Swan_soundbar_DVT_MIC_Soldeirng

ALT Co., Ltd.

Issued Date 2021.04.01

Ver.1.0

NG

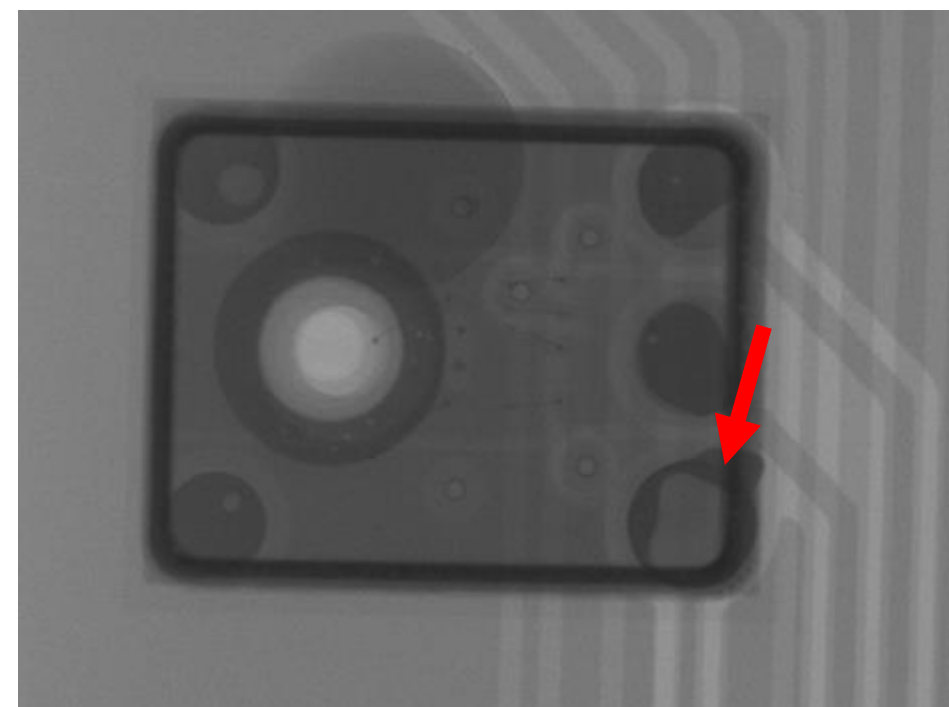
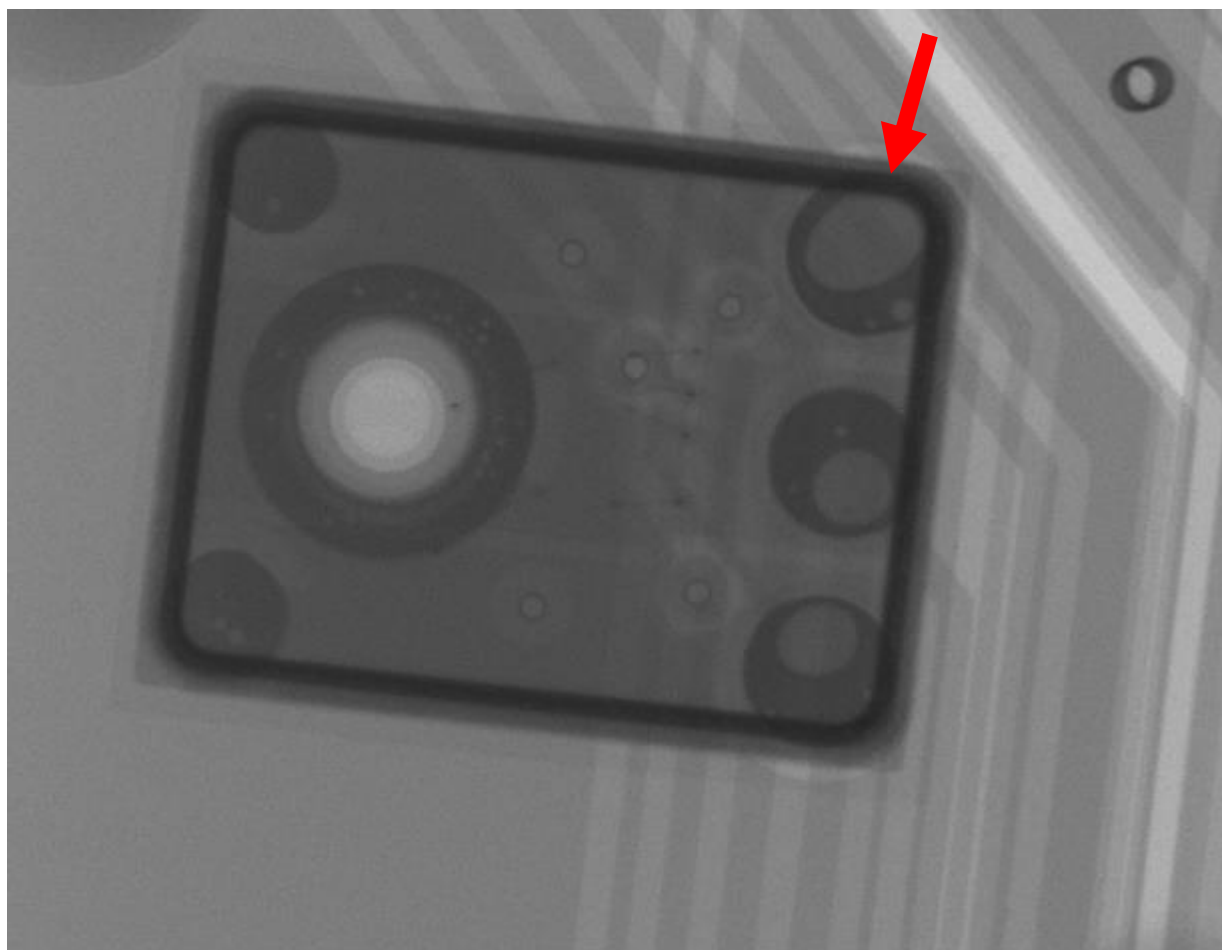
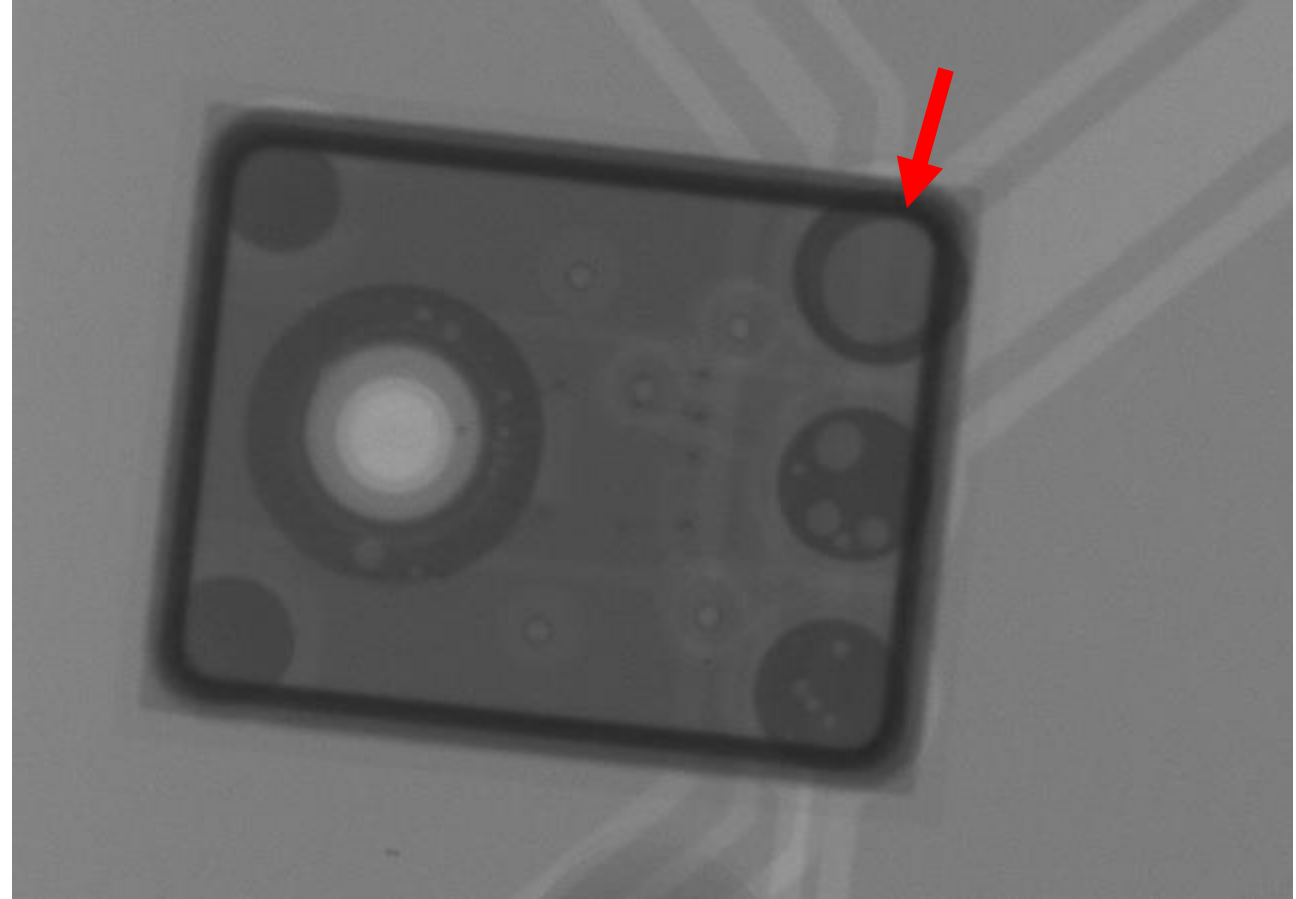
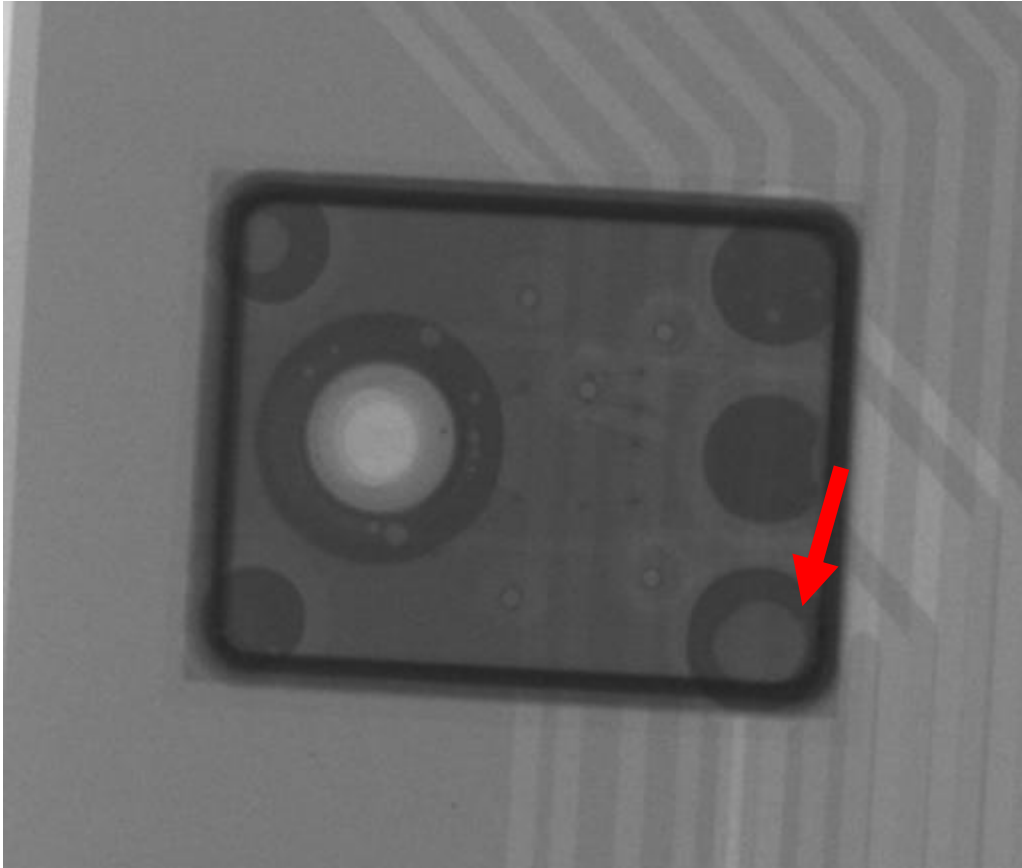
- X-ray inspection for DVT3 MIC PCBA
 - Q'ty : randomly 5pcs
 - One of MICs on MIC PCBA signal pin soldering condition is NG
 - The bga void is lager then 25% over.
 - This void is make a negative effect on the reliability of the board
 - In particular, soundbar vibration adversely affects reliability of MIC function.
- ALT will follow IPC-A-610 standard.
 - ALT will add the special inspection item for Mic soldering conditions on manufacturing specification of SWAN
 - Fii manufactured MIC pcba was problems with each build.

- Factory Action item
 - report the optimum soldering conditions for MIC PCBA
 - i.g. Metal mask(stencil), Screen printer, reflow profile,, etc
- Report the test and validation plan for MIC soldering conditions
 - O-ring, solder balls, Void, etc..
